DAVIS-BESSE NUCLEAR POWER STATION
UNIT 1

IMPROVED TECHNICAL SPECIFICATION CONVERSION LICENSE AMENDMENT REQUEST

VOLUME 9 (Rev. 1)

SECTION 3.4 - REACTOR COOLANT SYSTEM (RCS)

Figure 3.4.16-1

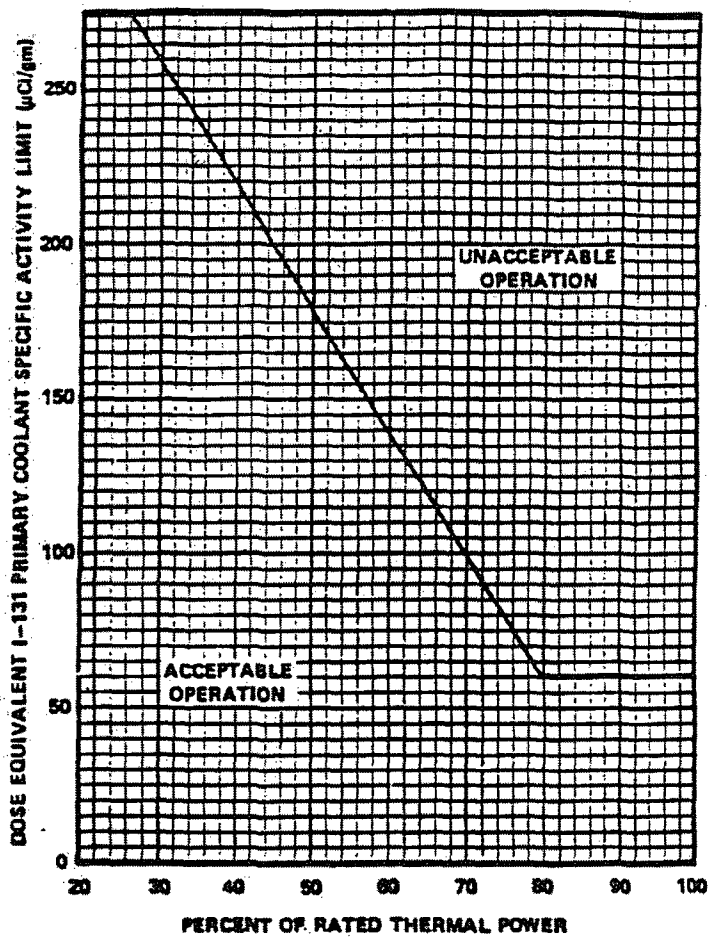
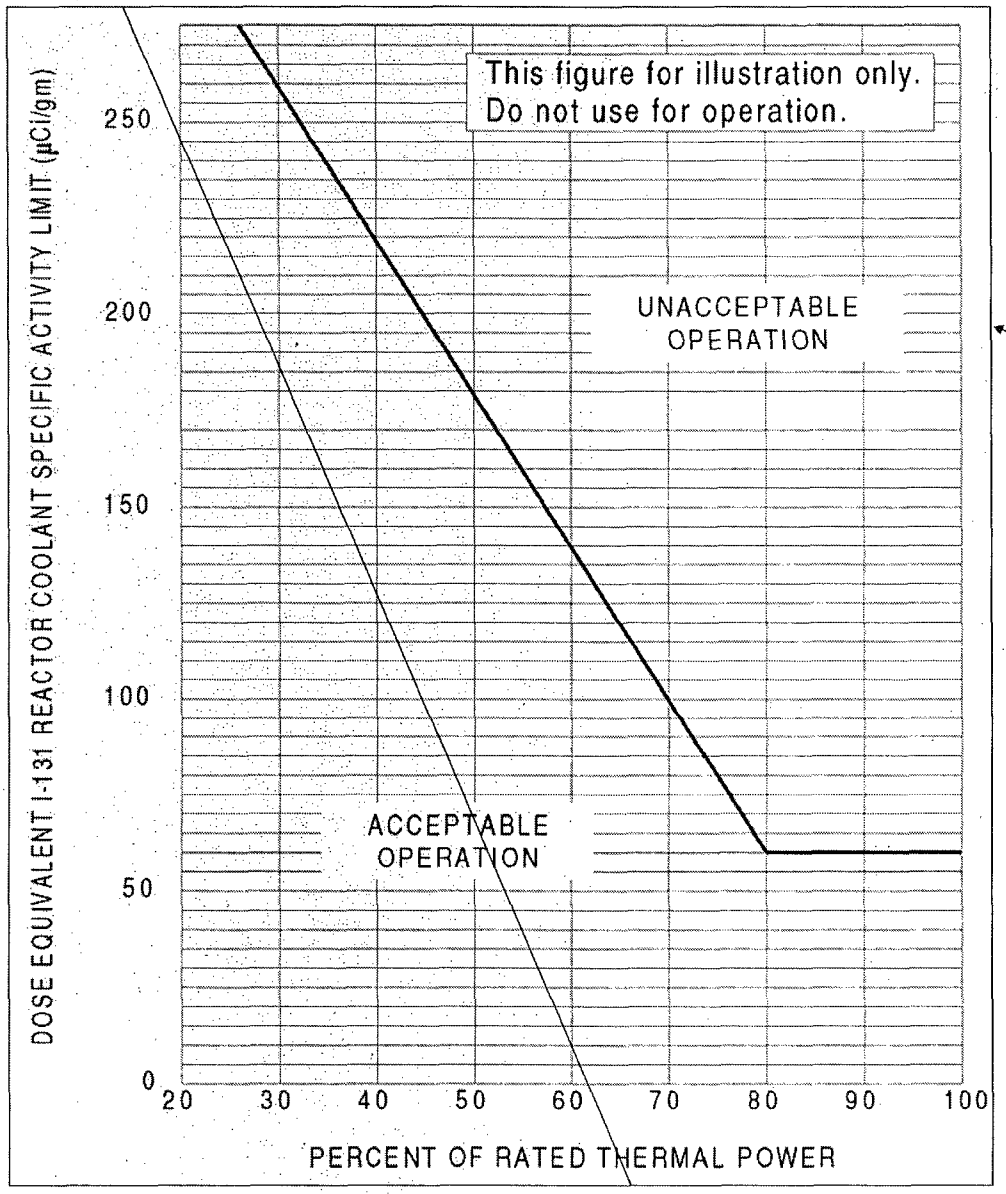
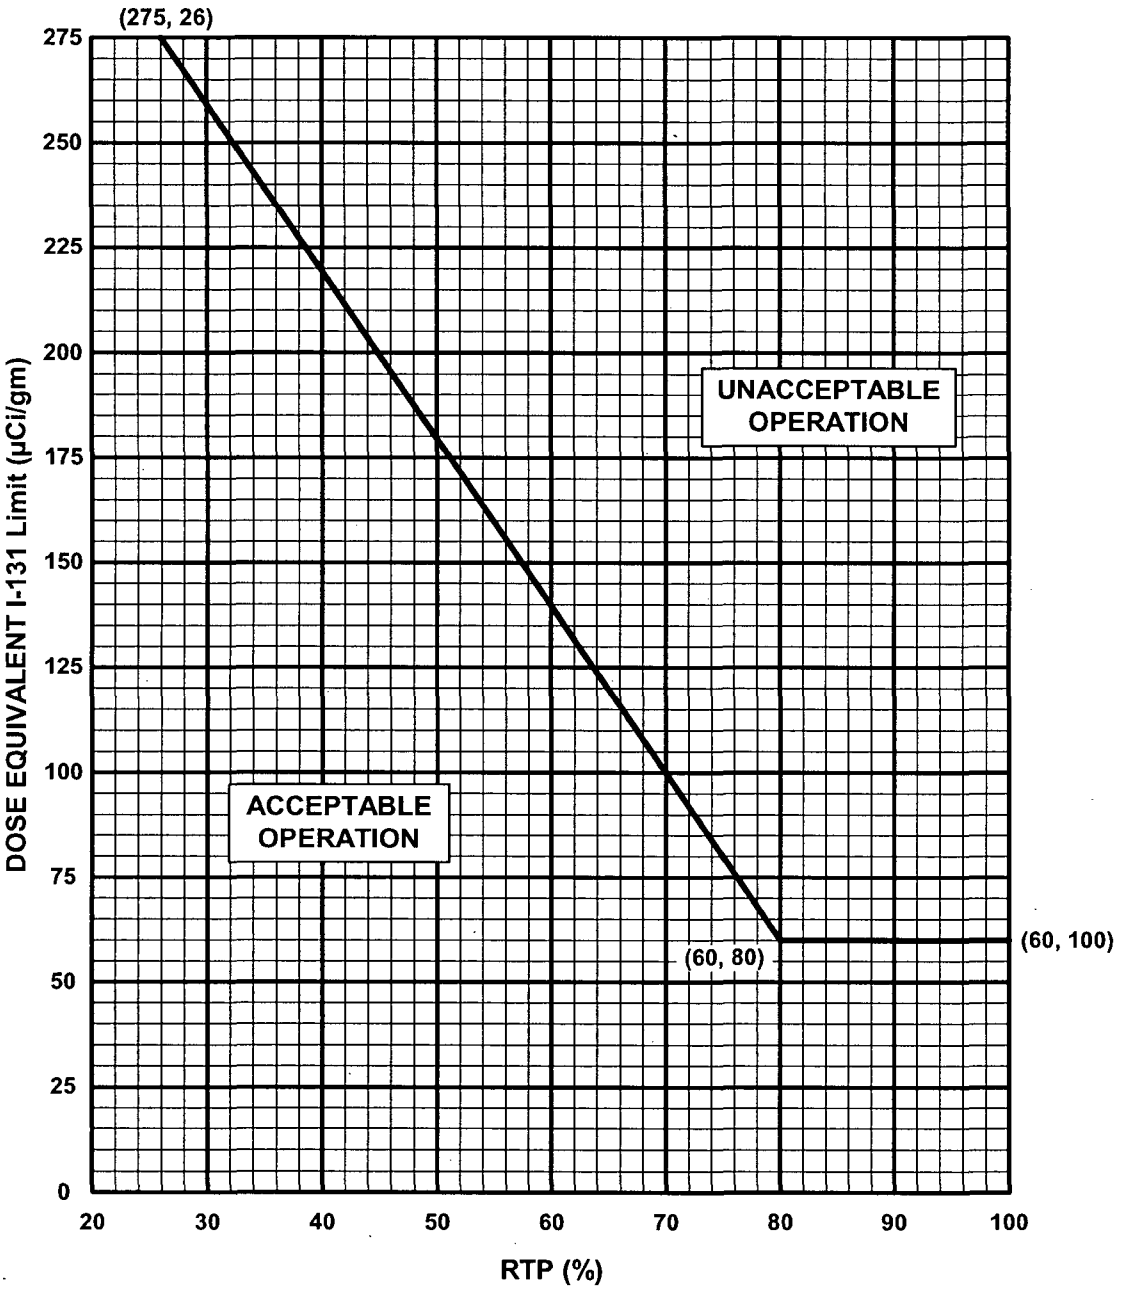
1. The MODE 3 Applicability for this Specification has been changed from 500°F to 530°F, consistent with current licensing basis. The Davis-Besse temperature limit is 530°F, since at this temperature the saturation pressure of the primary coolant is below the lift pressure of the main steam safety valves.
